TABLE OF CONTENTS

January 21, 2020

Sahu Report = Dr. Ranajit (Ron) Sahu, Technical Comments on EPA's Proposed Rule to Revise the Best Available Technology (BAT) Effluent Limitations Guidelines (ELGs) for Flue Gas Desulfurization (FGD) Wastewater and Bottom Ash Transport Water (BATW) ("Sahu Expert Report") (attached)

Figure LU1. Per-MWh compliance costs for bottom ash transport water under Option 4, plotted against generation.³⁸⁸

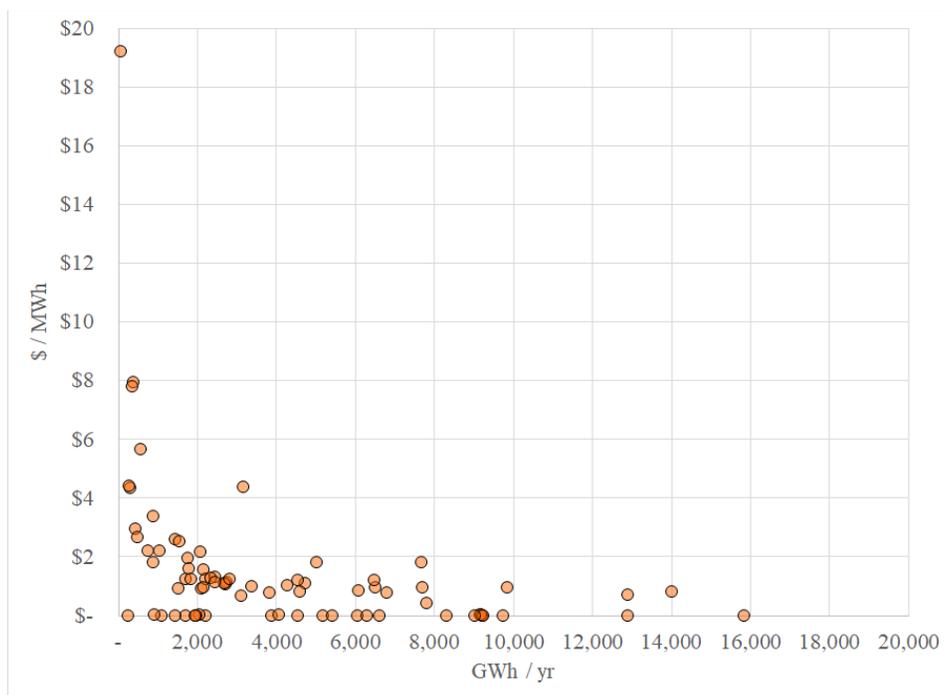
We aggregated generation and annualized³⁷⁹ compliance costs at the plant level, keeping the two wastestreams separate, and plotted per-MWh compliance costs for Option 4 in Figures LU1 and LU2 below. Similar figures using Option 3 costs would be substantially the same.³⁸⁰ These figures show three things. First of all, contrary to EPA's depiction in Figure VIII-1 of the 2019 Proposal, there are very few plants that appear to fall into a low-generation cluster with higher per-MWh costs. This is particularly true for FGD wastewater, where there are at most two plants that fall outside the main group of plants. This shows that EPA is effectively creating a plant-level exemption, which is something that it is legally prohibited from doing.³⁸¹

Figures LU1 and LU2 also show that the cost-MWh relationship is not the same for the two wastestreams. For bottom ash transport water, there is some evidence that per-MWh costs are higher at lower levels of generation (even if they never rise to the level of “disparate”). For FGD wastewater, on the other hand, there is no such evidence. Two of the low-generating plants have above-average costs, but another two low-generating plants have very low costs (in fact, zero cost). Overall, the costs are largely unrelated to generation.

Figure LU3. Per-MWh compliance costs for bottom ash transport water under Option 4, plotted against capacity factor.³⁹⁹

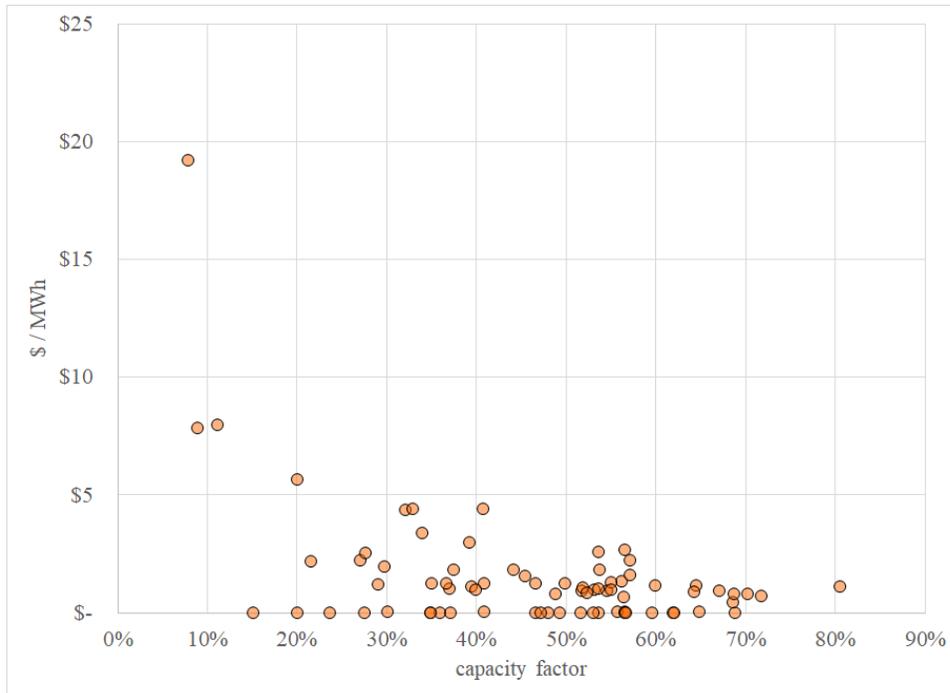
EPA also fails to explain why it did not evaluate compliance costs on the basis of capacity factor rather than raw generation. Again, the purported source of EPA’s concern is that certain units will have disproportionate costs, with those units being cycling or peaking boilers and larger ones that are generating fewer and fewer MWh per year.³⁹⁵ In that case, EPA should have evaluated the compliance costs sorted by capacity factor. We do that in Figures LU3 and LU4 below.³⁹⁶ These figures show that, aside from at most three plants’ bottom ash compliance costs, there is no relationship, or at most a very weak relationship, between per-MWh costs and capacity factor. In other words, plants that run less often do not have significantly higher per-MWh costs than plants that run more often.³⁹⁷ EPA’s concerns about power plants that operate at

low capacity factors (e.g., peaking and cycling boilers) and about “ensuring electricity reliability”³⁹⁸ are simply unfounded and not at all supported by the record.

Figure LU5. Per-MWh compliance costs for bottom ash transport water under Option 4, using compliance with 2015 rule as a baseline.⁴⁰⁵

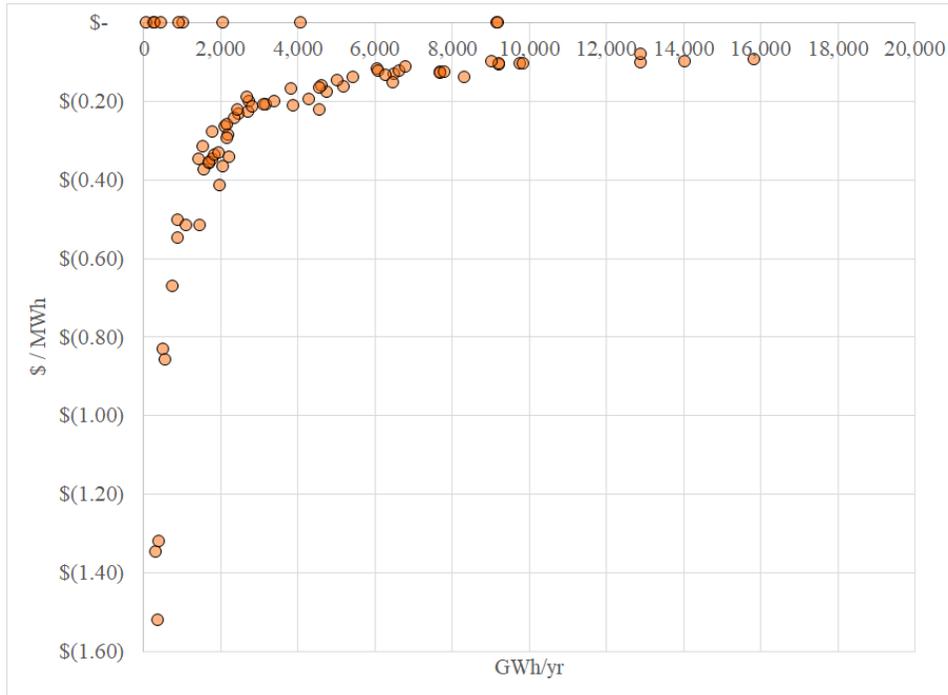
treatment, the entire industry would save money (relative to the 2015 Rule), and low-utilization plants would actually save more money than other plants. For FGD costs, some plants would see a cost increase while others would see a cost savings, but there is no relationship between the cost impact and generation.

Figures LU5 and LU6 show that if EPA used the same baseline it used elsewhere in the rulemaking record, it would have to conclude that the “low-utilization” units are better off than other units, even under Option 4. This directly contradicts EPA’s suggestion that these units would face “disparate costs” and further establishes that the Agency’s rationale for a low-utilization subcategory is arbitrary and capricious.

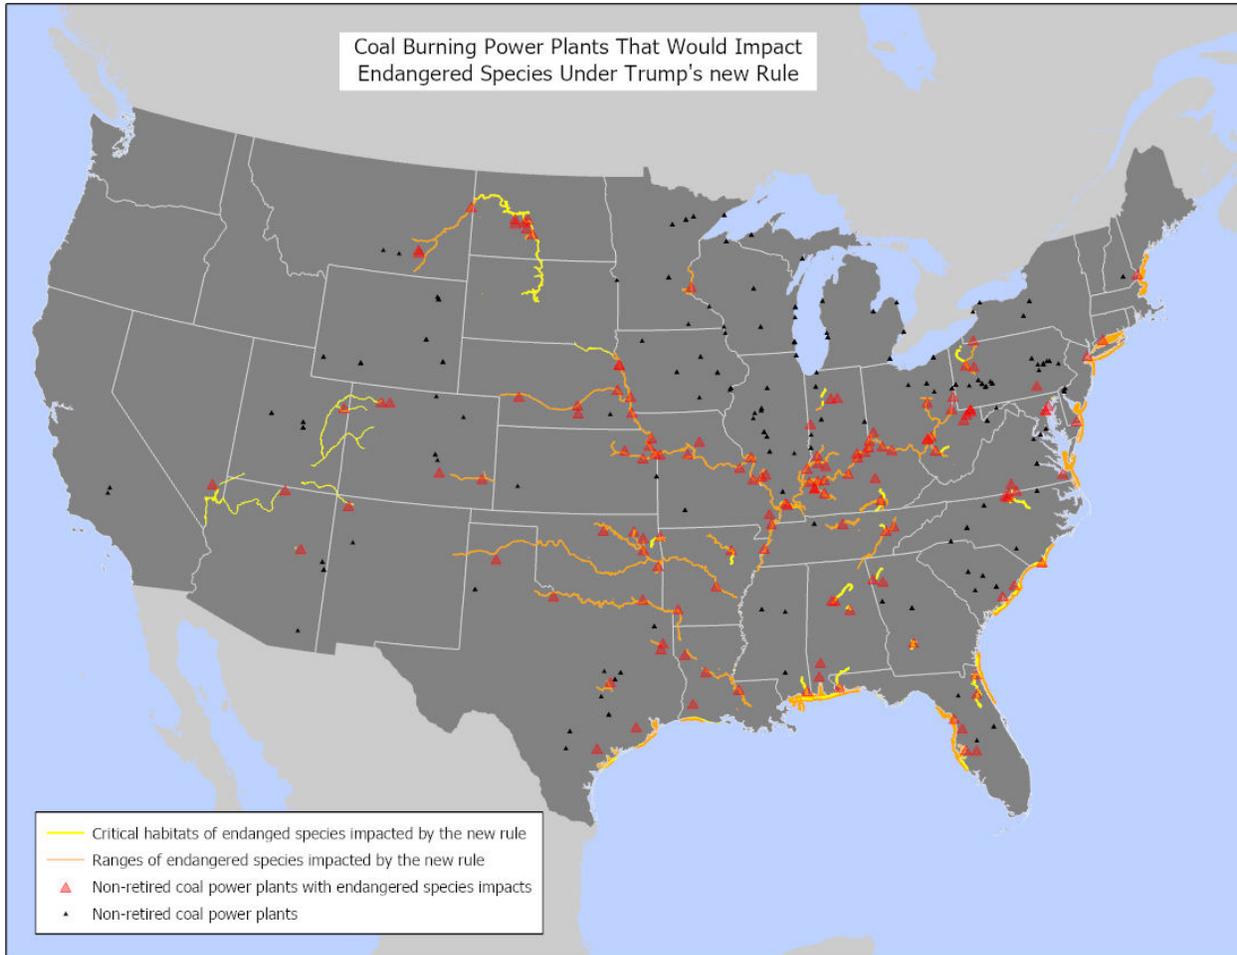
Indeed, as the following map illustrates, the overlap between the ranges and critical habitats for these federally-listed species and existing coal-fired power plants are significant and clearly trigger EPA's Section 7 consultation obligations.⁷⁴⁴
